This Service Information bulletin supersedes SI B13 02 15 **dated May 2015**.

Service Action: N63 Replace High-Pressure Fuel Pumps

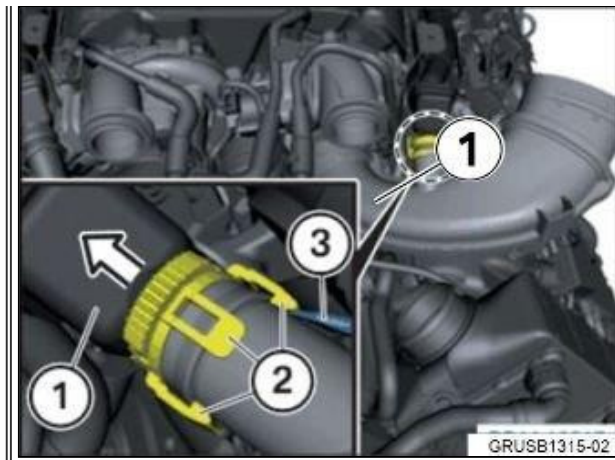
The high-pressure pump quantity control valve may fail.

Replace both high-pressure pumps. Refer to the following Repair Instruction 13 51 065, "Remove and installing/replacing the left high-pressure pump (N63)," and 13 51 070, "Remove and installing/replacing the right high-pressure pump (N63)."
